Attachment E

9830 and 9832 Wanda Park Drive- 2/10/26 BABCNC PLU meeting-

4) Request for decreased sideyard setback 4' versus the required 8' based on height

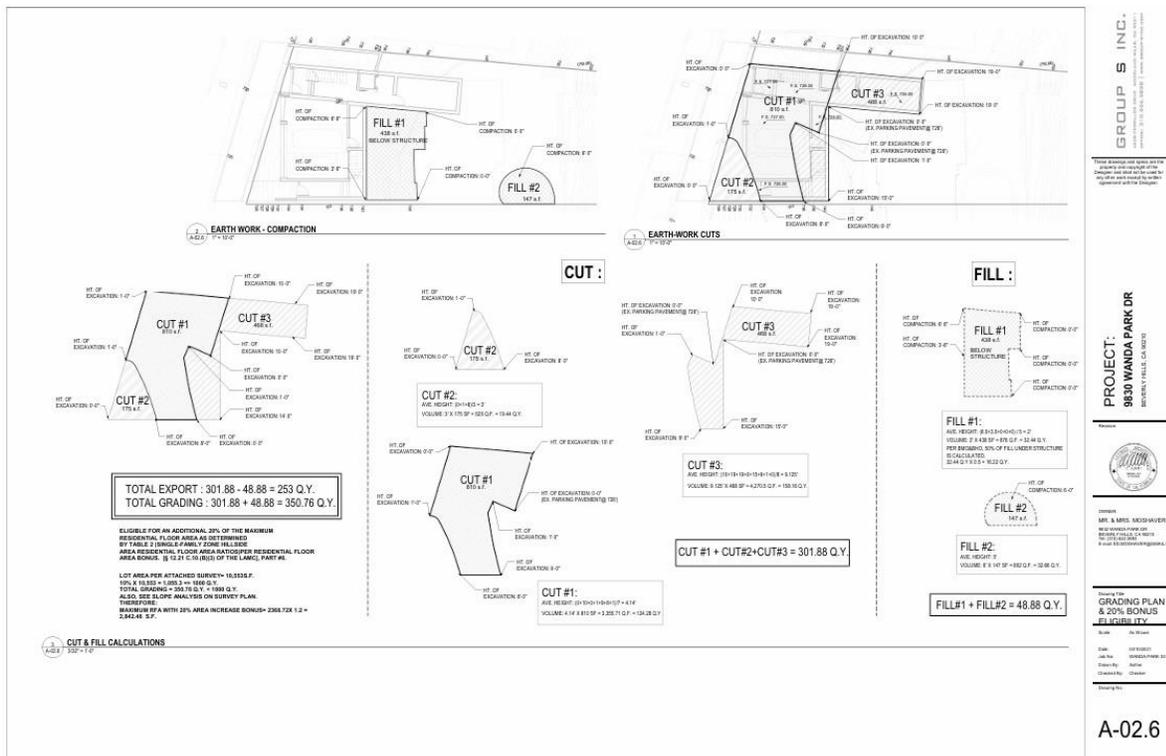
Applicant is requesting a reduced SYSB for a structure that is 40' tall as measured from the lowest grade to the parapet. Floor to ceiling heights of 9' and 10' does not help the findings for this request.

PLAN, NTS

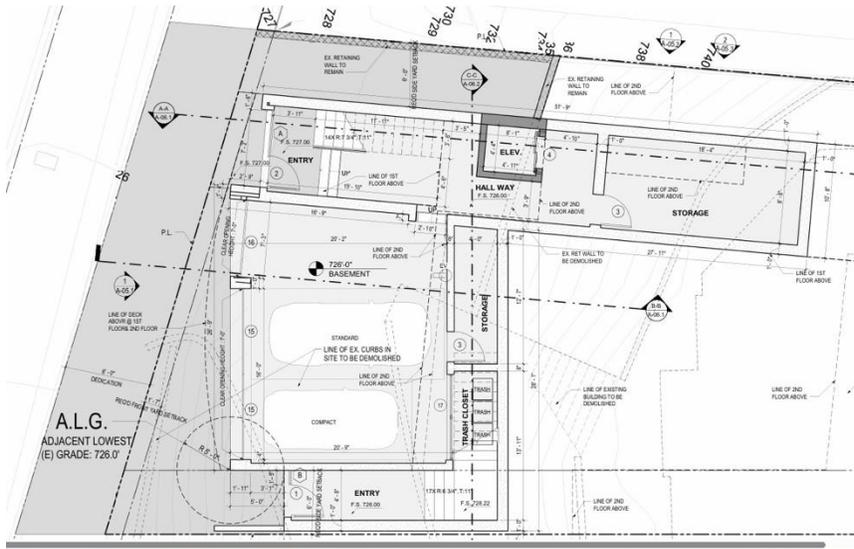
The drawing A-2.6 shows rough areas but does not show the complete project. For example: the cut for JUST the garage and first floor (guest) shows a cut of 624 CY, based on the dimensions on their drawings and the dashed grade line.

SECTION, NTS

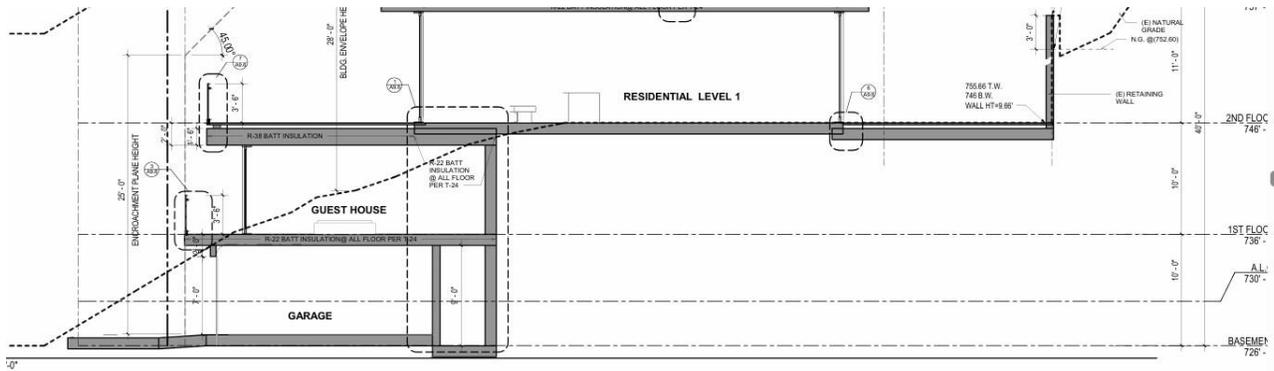
Additionally, the grading line information is missing all foundations (for buildings & walls) and the likelihood that BOTH the uphill retaining wall (wall built in 1952 and pool in 1963) and the side yard walls would be undermined by the deep cut for the proposed house (rear & side yards) and therefore even more additional grading would be required. Grading approval letter could have shed light on this issue. Applicant needs to prove they comply with the area bonus. And a haul route could be needed if the total exceeds 750 CY, based on CPR width.
